PLAN REVIEW SHEET

Petition #: RZP 2021-061

Address: 4700 Prosperity Church Road

Request: UR-2 CD

WAITING PAD ONLY WITH PLANTING STRIP STANDARD

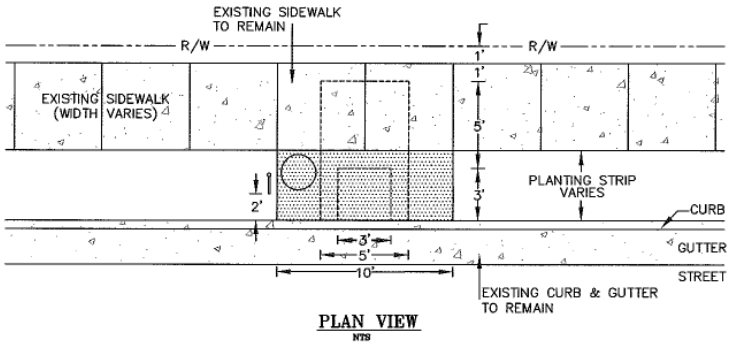
The site is located along CATS local bus route #59 along Prosperity Church Road. CATS requests the construction of an ADA compliant bus pad per Land Development Standard 60.01B on Prosperity Church Road. The final location of the pads will be coordinated with the developer through the permitting process.
